Service Information

Category U	Repair Guidance	Ref. No. R107/16REV	Page 1 of 6
Coverage <input type="checkbox"/> Distributor only <input checked="" type="checkbox"/> Please inform your dealers		Date Issued December 1, 2016	
Please convey this information to your <input checked="" type="checkbox"/> Warranty Dept. <input checked="" type="checkbox"/> Parts Dept. <input type="checkbox"/> Training Dept. <input type="checkbox"/> Field Rep.		Date Revised December 22, 2016	
Applicable Model Mazda2(DJ), CX-3(DK)		Applicable Countries or Specifications Worldwide

Subject: Air Conditioner - No Cool Air (Evaporator Leakage)

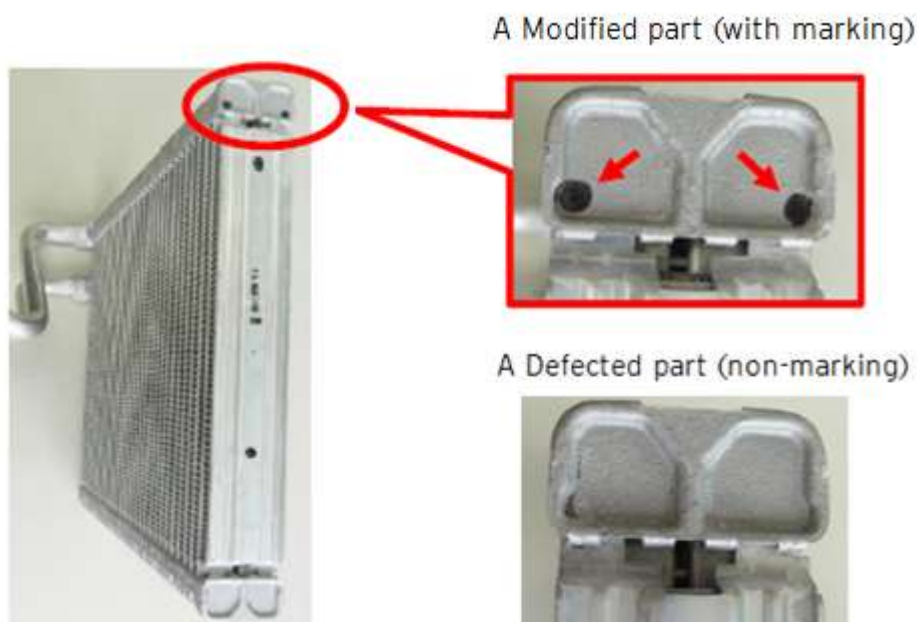
MASS PRODUCTION CHANGE

The configuration of the header has been changed to improve the brazing workability and performance from August 1, 2016

NOTE: A modified part can be distinguished by its black circled marking in the picture below.
